RE: Determination for an Administrative Master Plan for SODO House by the Lake town-home development at 316 W Michigan St, Orlando, FL **MPL2020-10017**

We have received your request for an Administrative Master Plan Determination for the proposed town-home project at 316 W. Michigan St. (parcel #02-23-29-0000-00-017), specifically you are requesting to construct a 25 unit, fee simple townhome development.

Overall Site Plan

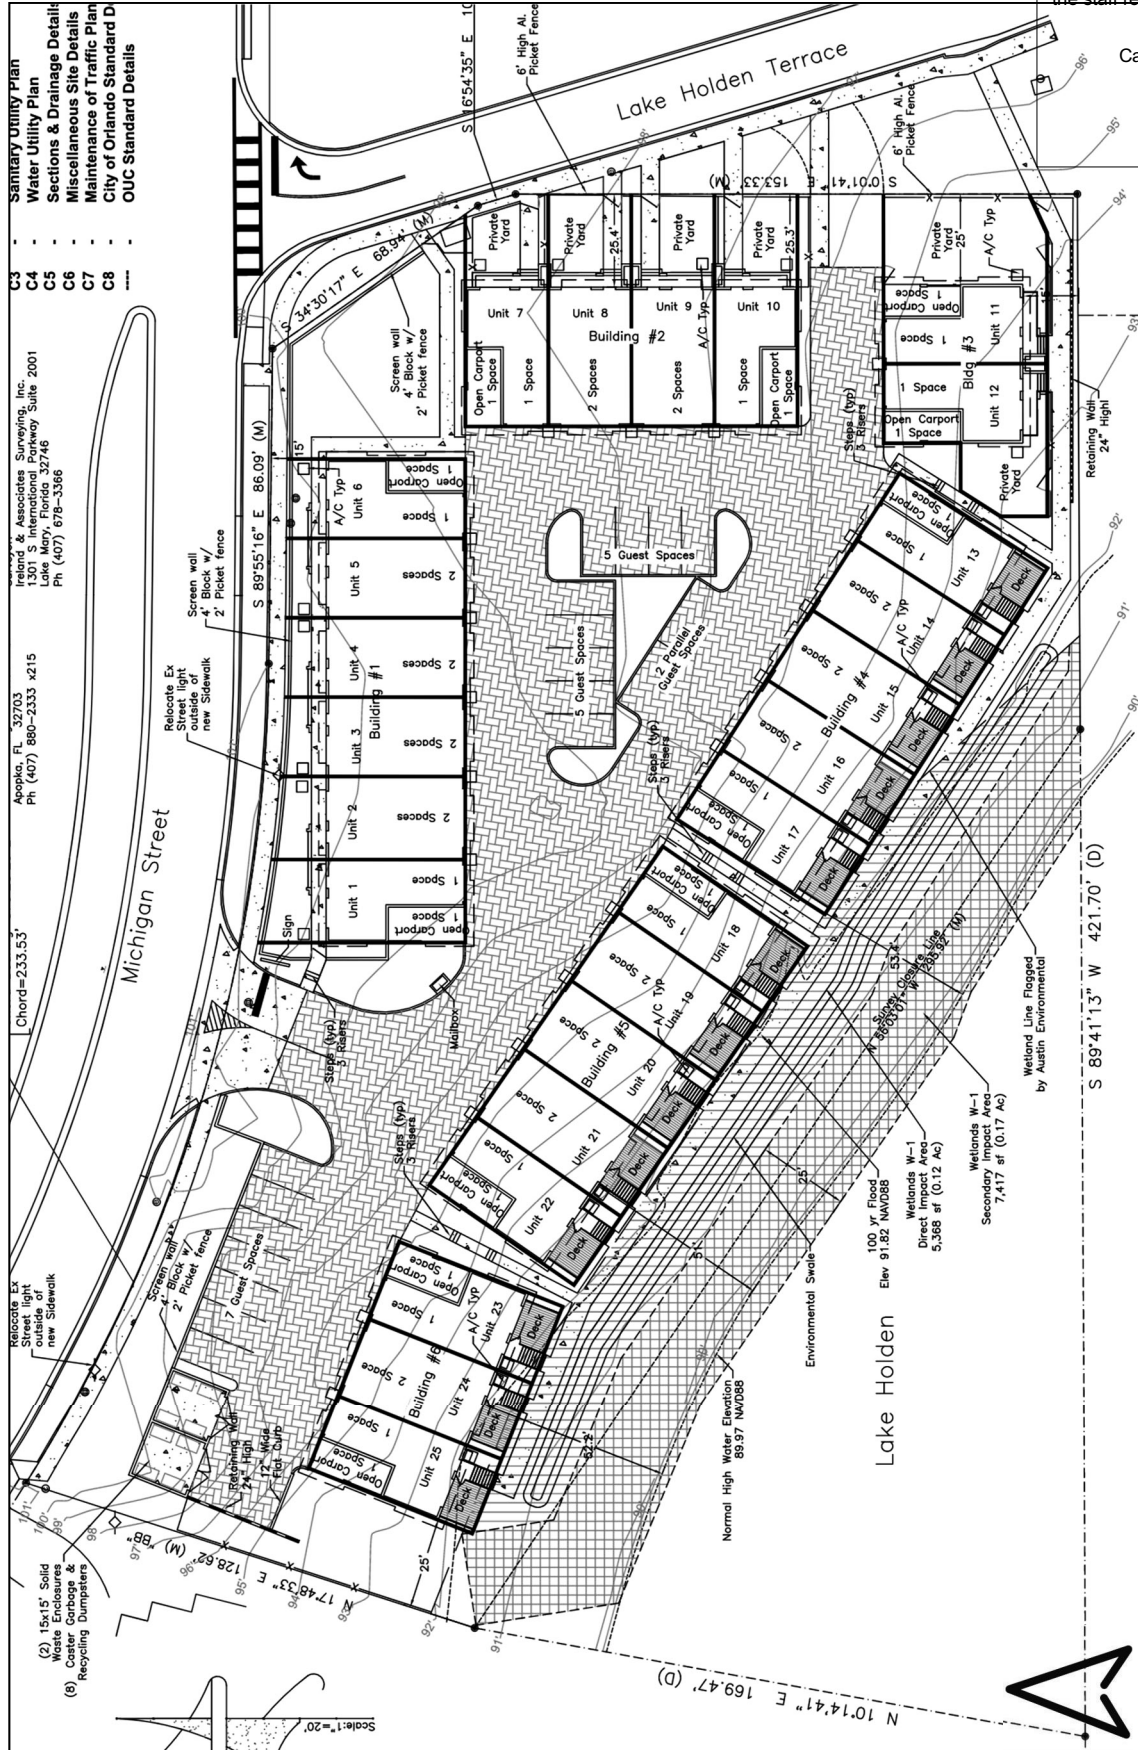
Setbacks – The R-3A district is subject to the following setback standards: front setback (Lake Holden Terrace) and rear setbacks of 25 ft. each, a street side setback (Michigan Ave.) of 15 ft. and a minimum side setback of 15 ft. Portion of the side is adjacent to a waterbody (Lake Holden) and will require a 50 ft. setback from the Normal Highwater Elevation Mark.

Bufferyards – Bufferyard 'A' (5-7 ft. wide) is required along the southern and western property boundaries. Where the bufferyard width is less than 7 ft. wide, a 6 ft. tall masonry wall must be provided. LDC section 65.302 allows administrative reduction not to exceed 50% of the code requirement for landscaping. You propose a 2.5 ft. width along the southern boundary that is not part of the lake. Therefore, a 6 ft. tall wall is required along the southern property line.

Site Plan – The proposed site plan appears to comply with the R-3A development standards, except as noted on recommendation below.

9. Drive Aisle Width - The drive aisle must be a minimum of 23' to allow for maneuvering from the perpendicular parking spaces and the garage spaces (Figure 17 in Section 61.399). This can be 23' of clear pavement, or 22' of clear pavement and 2' clear area adjacent to the 22'.

Landscape Plan

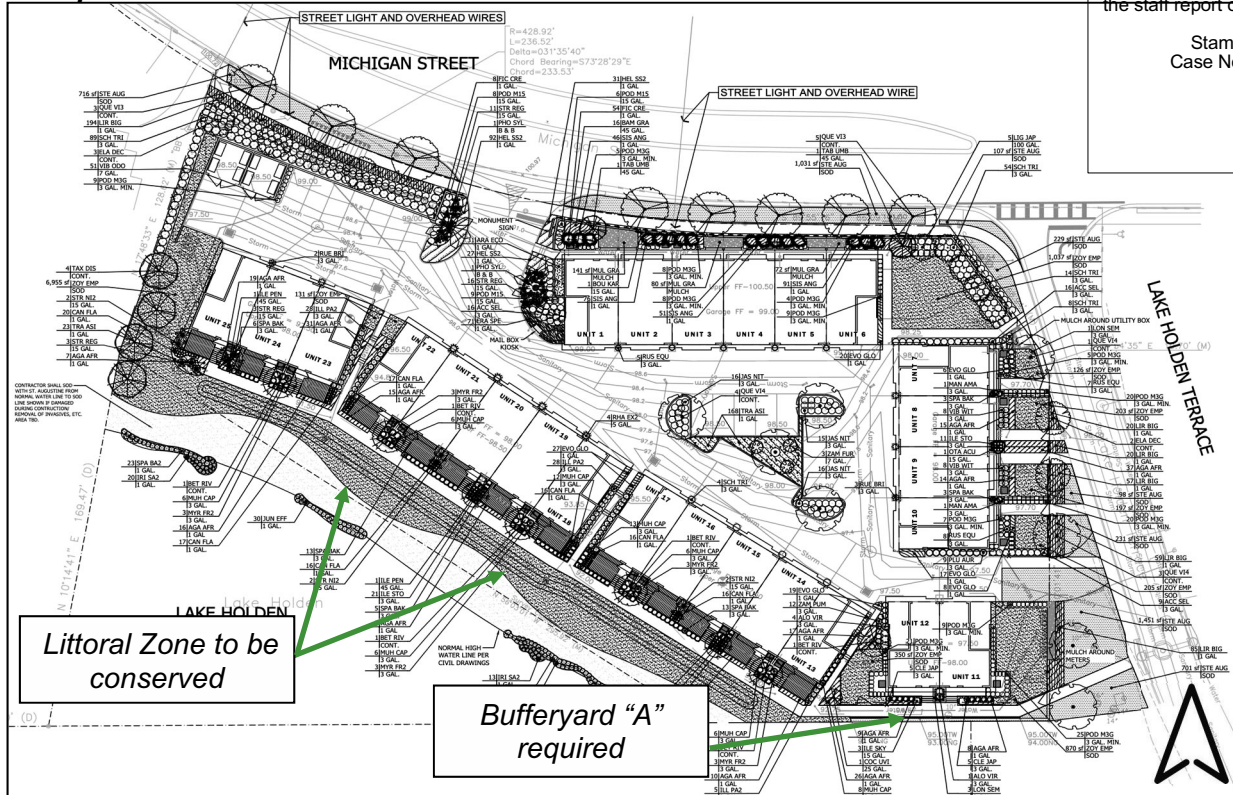
3. The parkway strip must be a minimum width of 7.5ft.
4. Street trees must be provided along Michigan St. and Lake Holden Ter.
5. Townhomes are required to meet the multifamily standards of the landscaping code (Chapter 60) for the development site as a whole. In addition, stormwater swales or ponds are not allowed in the front or street side setbacks unless low impact design standards for rain gardens are met.

6. Adjacent to wall along Michigan St, must be at minimum a 2ft landscape strip for low growing plantings.

Fire Access

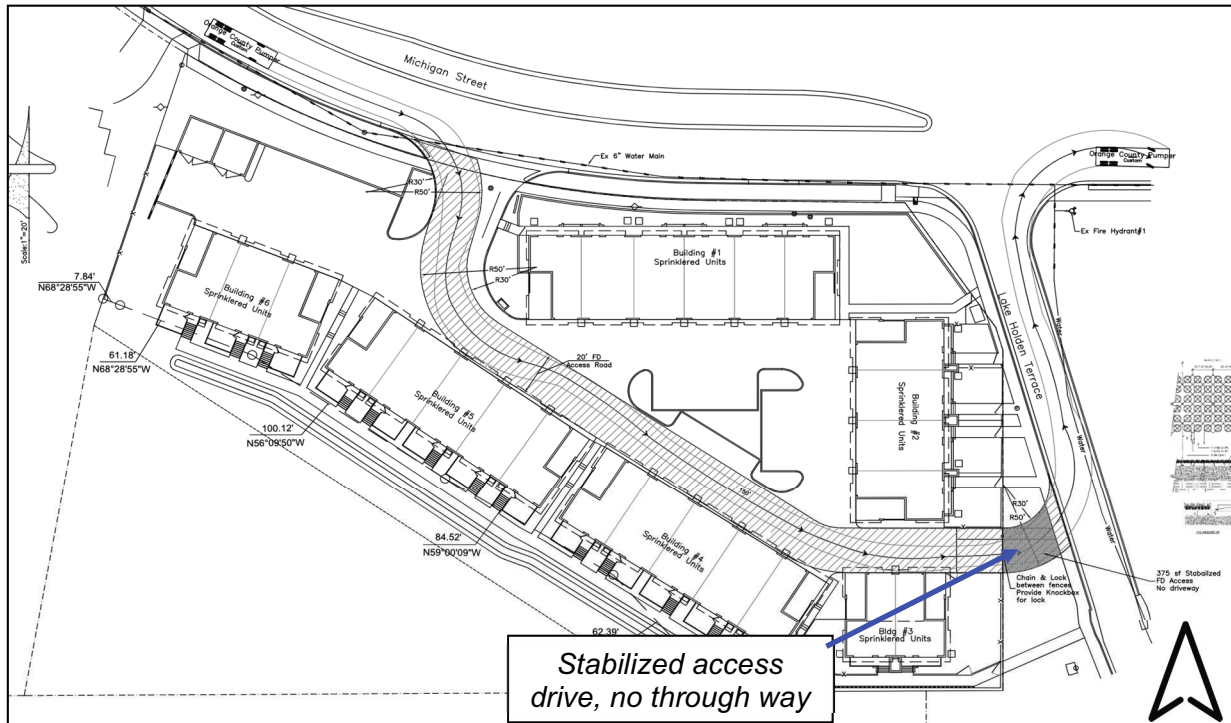
5. Approved Turnaround: an approved turnaround shall be provided for fire apparatus where an access road is a dead end in access of 150 ft. When a dead end road will not accommodate an approved t-turn or turn-a-bout a minimum width of 25 ft. will be required. The turnabout shall be the minimum 20ft. width of the fire department access road and sized for the dimensions of the largest OFD apparatus. Use of areas subject to obstruction by vehicles such as loading docks and parking garages are prohibited. Acceptable turnarounds can include T-turn, Y-turn or cul-de-sac (designs and dimensions are subject to the approval of Orlando Fire Department). See Exhibits in NFPA Fire Code handbook. NFPA 1.18.2.3.4.4

6. Fire Department Access Road: All fire department access roadways shall have an all-weather driving surface, capable of supporting the load of fire apparatus, a minimum 20 ft. in width and a minimum vertical clearance of at least 13 ft. 6 in. [NFPA 1 18.2.2.5.4 and NFPA 1 18.2.3.4.1.1] City of Orlando apparatus requires a turning radius dimension of 30 inside and 50 exterior and shall maintain the minimum 20ft. width. An auto-turn analysis is required for the radius turns indicated on the site plan. NFPA 1.18.3.4.3.1 and NFPA 1.18.3.4.3.2

Aluminum screen on buildings 4 and 6 used for mechanical equipment screening

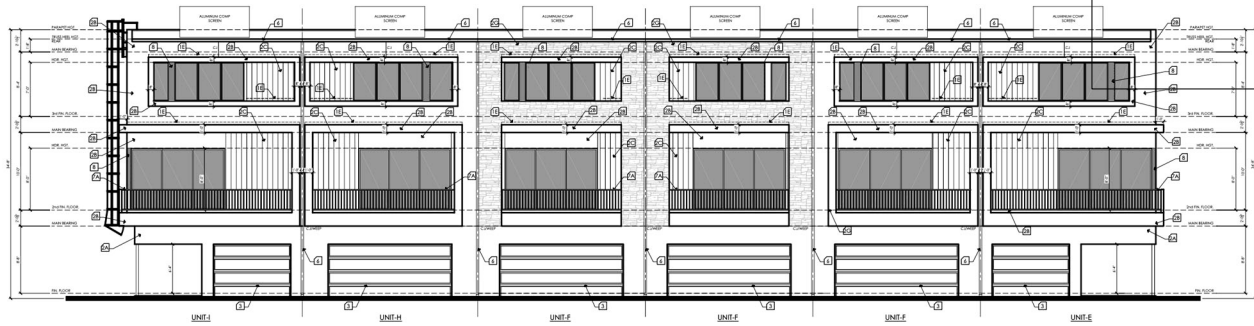
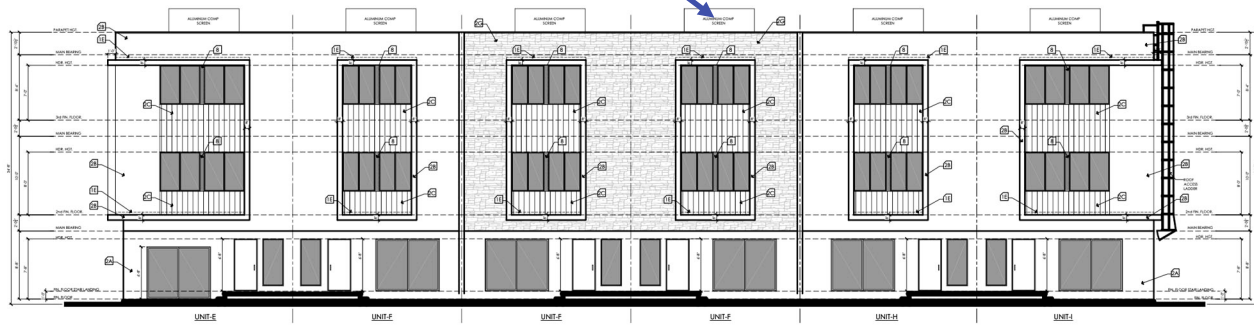
Height – The maximum permitted height is 35 ft. Roof decks that are either covered or open air are included within the height of the building at a minimum height of 8 feet. Buildings 4 and 6 contain an aluminum screen that exceeds the permitted building height and are permitted as they are part of mechanical equipment screening. Your overall proposed height of +/-35 ft will meet City code.
